STAFF REPORT

REGIONAL CENTER HEARING EXAMINER – HIGH IMPACT CASE

Case Number	2026-REG-006
Address (approx.)	219 Koehne Street, 1437 – 1533 (odd) Saulcy Street, and 1422 – 1528 (even) Astor Street
Location	Center Township, Council District #18
Petitioner	Union Holdings III, LLC, by Misha Rabinowitch
Zoning	D-8 (RC)
Request	Regional Center Approval to provide for demolition of existing dwellings and accessory structures and for construction of a multi-family residential development, consisting of approximately 242 units, an integrated parking garage with 258 spaces, and resident amenities, including a community room, a playground, dog park, and grilling area.

Site Plan

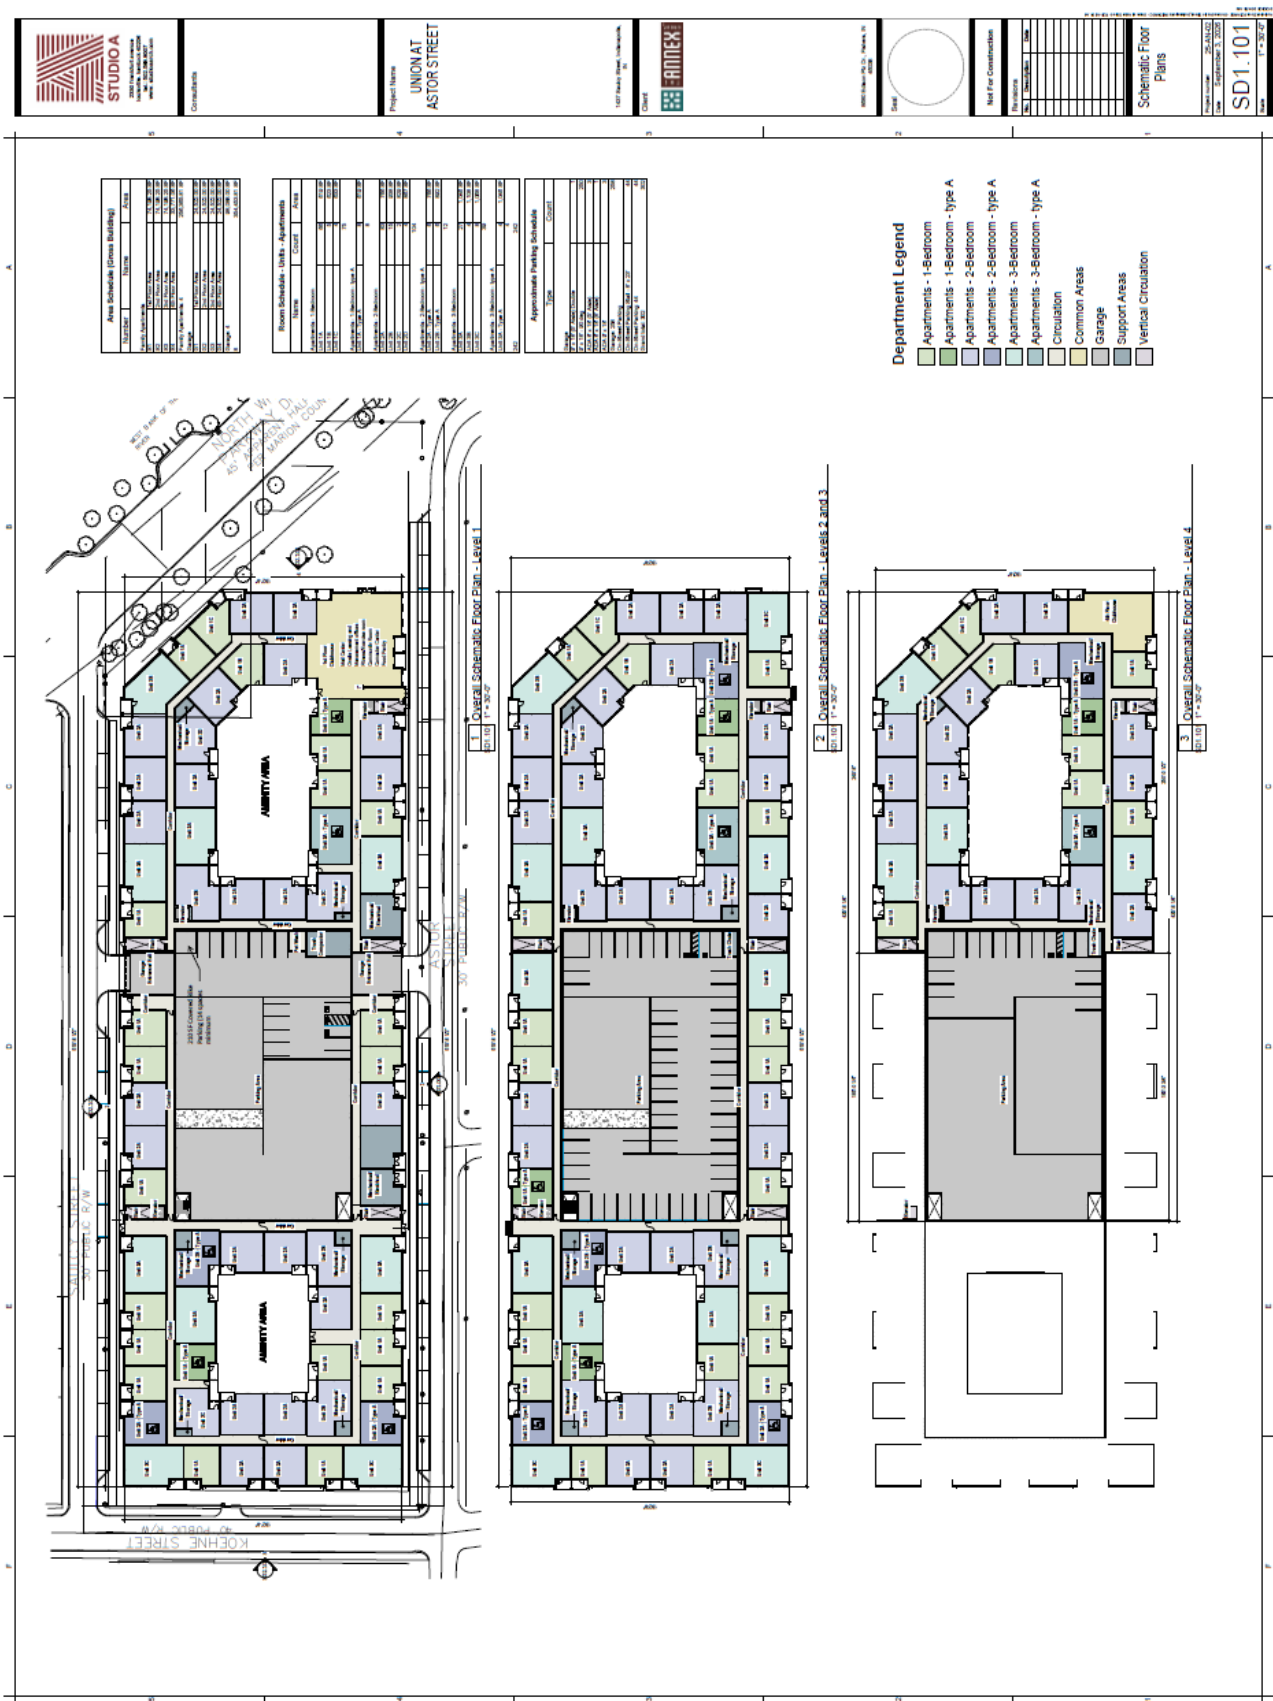
The proposed development would impact the immediate area; therefore, staff requested that building height step down from the east to the west. White River Parkway, West Drive is a primary arterial which runs along the west bank of White River and the Central White River Trail. According to the submitted building elevations, the structure would be four stories in height at the White River Parkway, West Drive, frontage and for approximately 1/3 of the length of the structure to the west. Then the structure would step down to three stories for the remaining 2/3 of the length, to Keohne Street.

Elevations

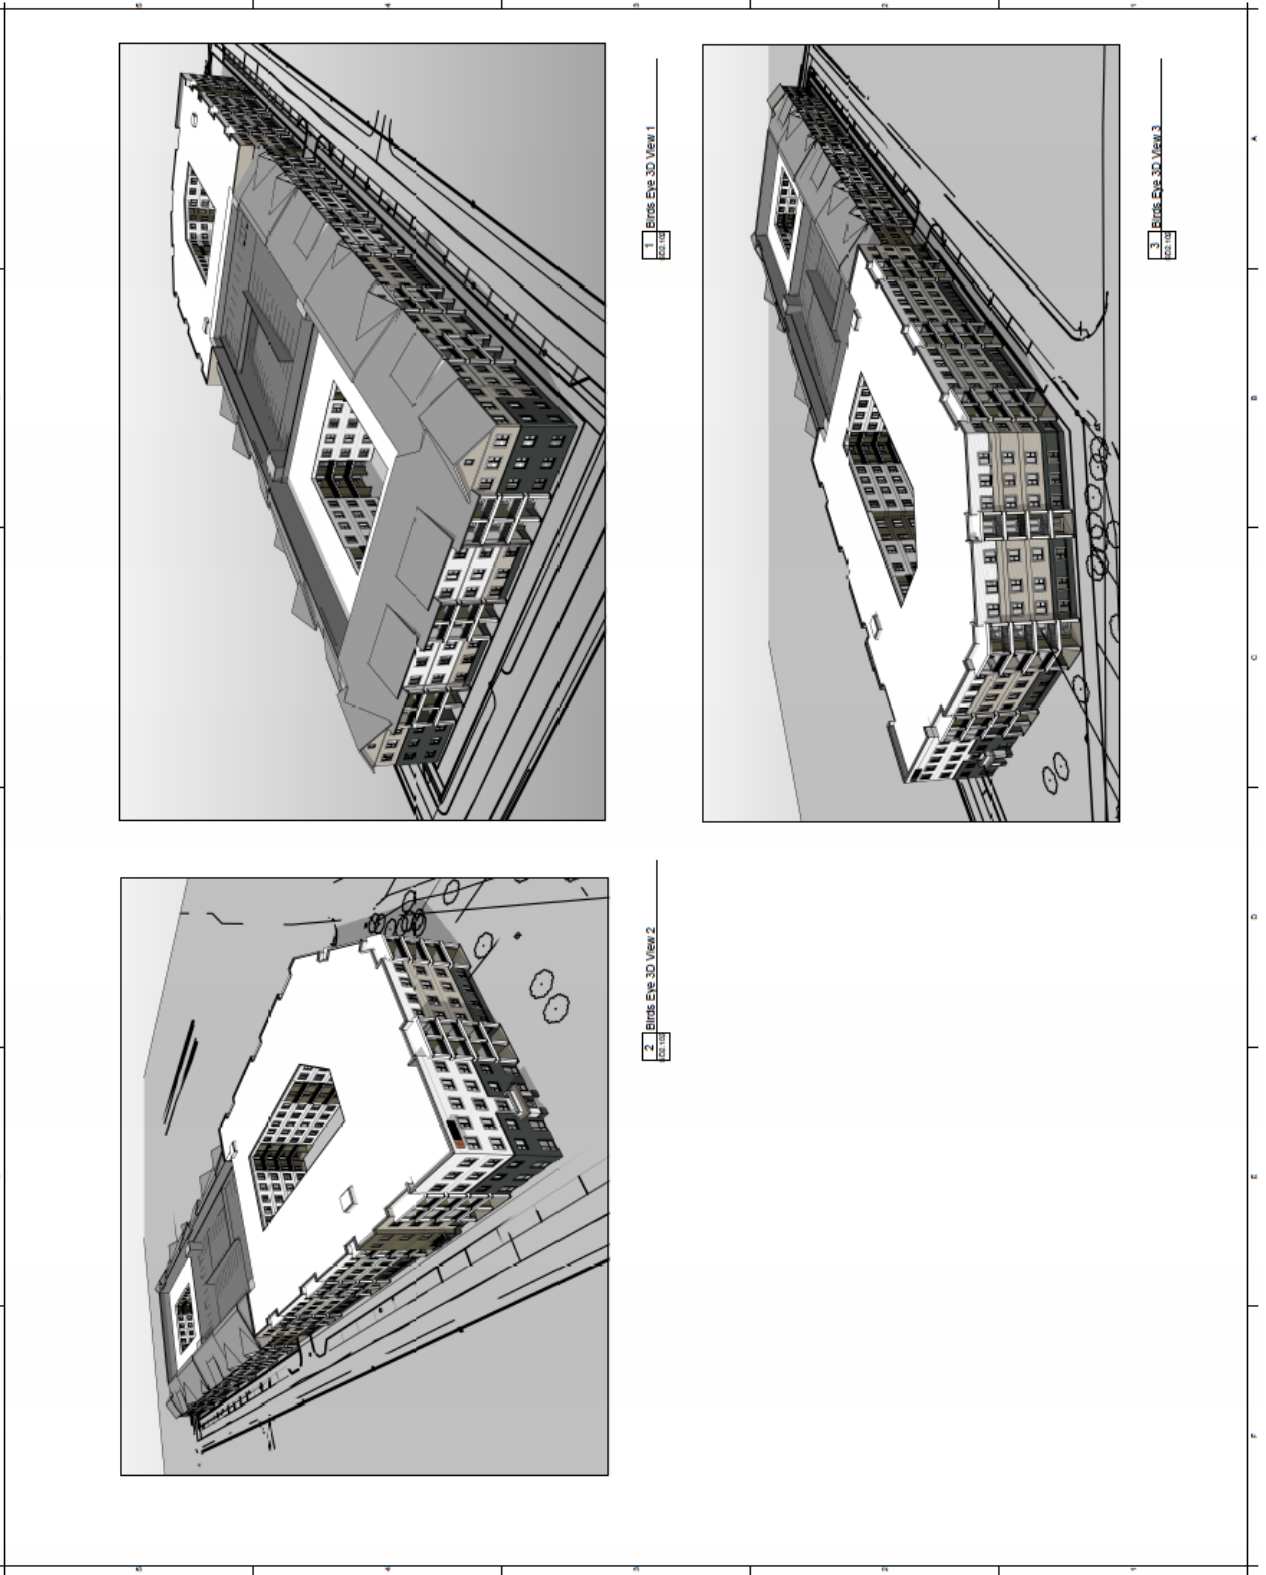
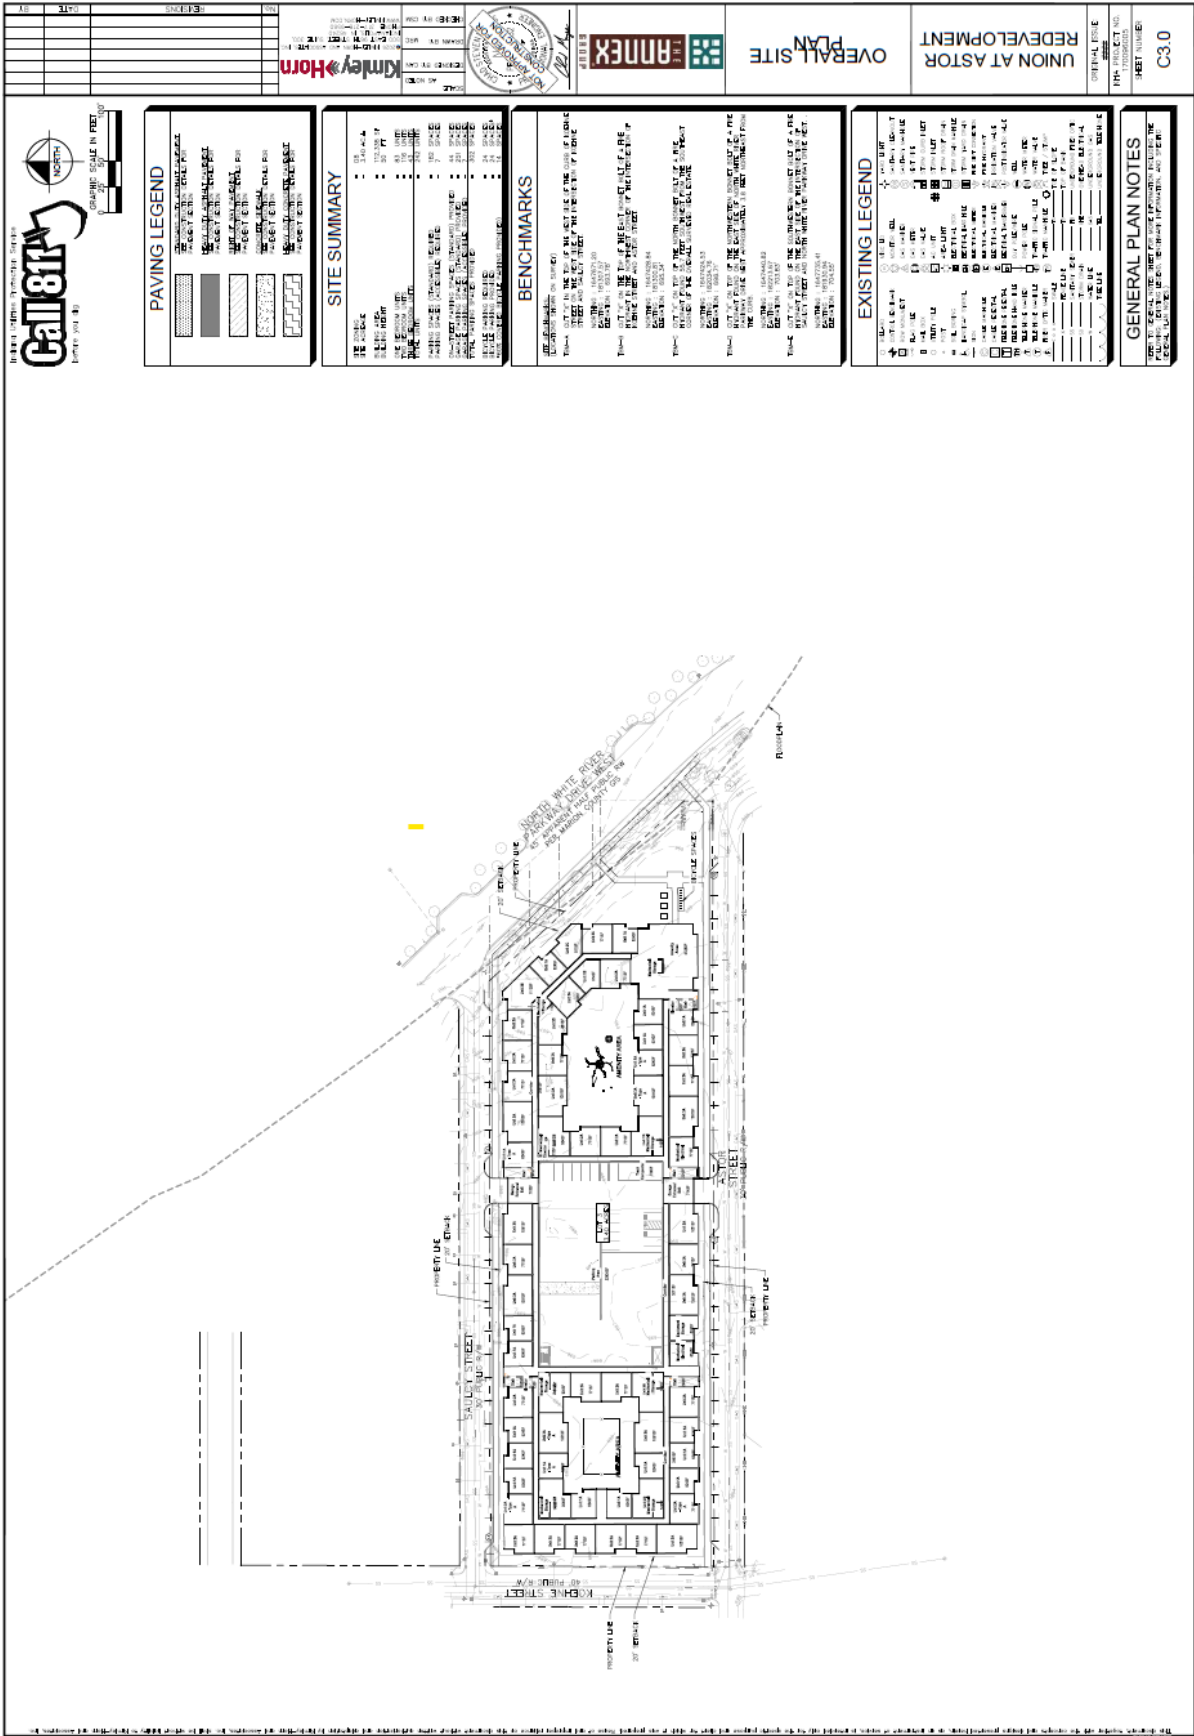
Building materials would be primarily fiber cement with a brick base, and larger sections of brick on the west façade that wraps around the building corners and at the first and second levels on south portion of the east façade and wraps around the corner.

2. The building materials are primarily made of fiber cement, a man-made material. Staff requested additional natural building material. Subsequent revised elevations note added areas of brick on the façade. Guideline CA 2.2.1 applies.
